Issue List

SPCC Aseptic Training Facility (Monroe, NC)

Project Issue Information

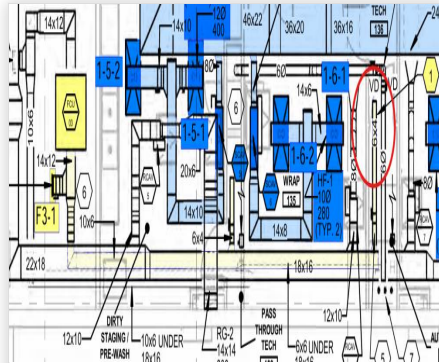
Issue Name : FCU F-2 Missing Grille
Description : FCU F-2 is missing the supply grille and is covered with plastic.
Created By : National TAB **Assigned To :** National TAB - Antonio Flores-De La Cruz
Status : Open
Priority : Urgent **Asset Tag :**
Originated Date : 02/19/2026 - Antonio Flores-De La Cruz - National TAB

- **02/24/2026 National TAB - Antonio Flores-De La Cruz**
 - Balanced without grille.

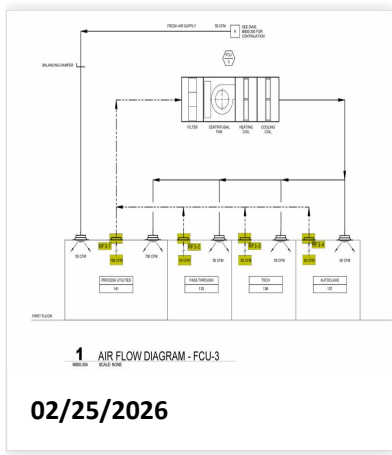
Issue Name : FCU F-3 missing damper
Description : Grille in AUTOCLAVE 137 for FCU F-3 is missing the OBD balancing damper. Also awaiting the Engineer's confirmation of increasing the grille from 50 CFM to 100 CFM, per the meeting on 2/19/2026.
Created By : National TAB
Assigned To : National TAB - Antonio Flores-De La Cruz
Status : Open
Priority : Urgent
Asset Tag :
Originated Date : 02/23/2026 - Antonio Flores-De La Cruz - National TAB

- **02/25/2026 National TAB - Antonio Flores-De La Cruz**
 - All supply and return grilles need dampers. Also, an RFI is needed to determine the new diffuser values. The actual installation does not match the design and needs clarification.

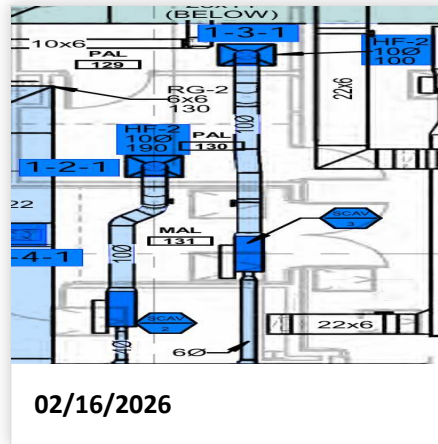
Issue Name : Flow Setpoints for SVAV-2 and SVAV-3
Description : SVA-2 and SVAV-3 do not match based on the schedule and connected load CFM values. Need clarification on what is required.
Created By : National TAB **Assigned To :** National TAB - Antonio Flores-De La Cruz
Status : Open
Priority : Urgent **Asset Tag :**
Originated Date : 02/16/2026 - Antonio Flores-De La Cruz - National TAB

- **02/25/2026 National TAB - Antonio Flores-De La Cruz**
 - IPS has returned the RFI to us, stating that we should switch the SCAV box tags and continue with the flows. Controls should change them and confirm completion with TAB.

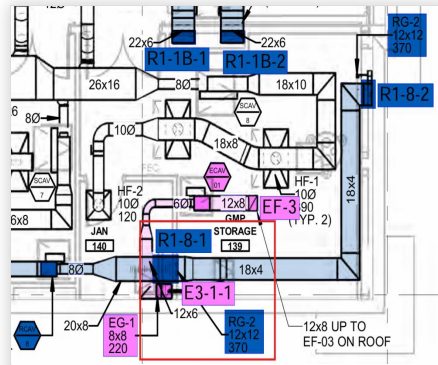
Issue Name : RCAV-8 Missing Grille / Low Airflow
Description : RCAV-8 is missing a grille. The VAV box is calibrated and can only achieve 640 CFM at 100% open damper. The rectangular duct attached to the grille appears to be sized for the 370 CFM design.
Created By : National TAB
Assigned To : National TAB - Antonio Flores-De La Cruz
Status : Open
Priority : Urgent
Asset Tag :
Originated Date : 02/25/2026 - Antonio Flores-De La Cruz - National TAB

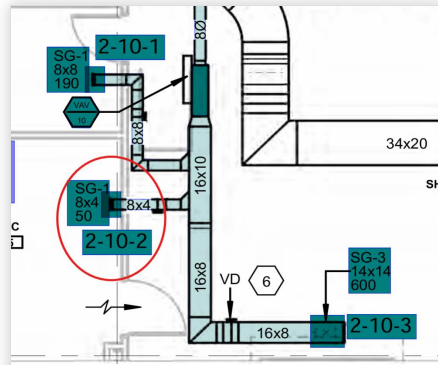
Issue Name : VAV-10 Missing Grille
Description : Grille 2-10-2 in ELEC 125 is not installed to balance. Total Flow was set in the meantime
Created By : National TAB **Assigned To :** National TAB - Antonio Flores-De La Cruz
Status : Open
Priority : Urgent **Asset Tag :**
Originated Date : 02/19/2026 - Antonio Flores-De La Cruz - National TAB

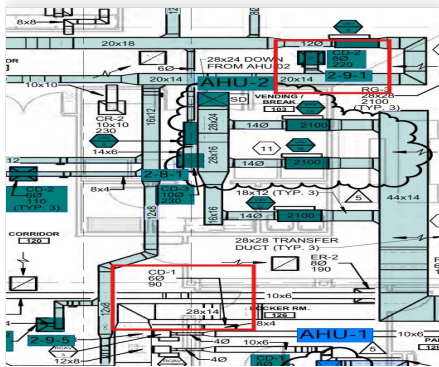
Issue Name : VAV-9 Missing Dampers
Description : Supply Diffuser in LOCKER RM 126 does not have a damper installed, as well as diffuser 2-9-1. 2-9-1 ductwork is also pinched and needs to be corrected.
Created By : National TAB
Assigned To : National TAB - Antonio Flores-De La Cruz
Status : Open
Priority : Urgent
Asset Tag :
Originated Date : 02/24/2026 - Antonio Flores-De La Cruz - National TAB
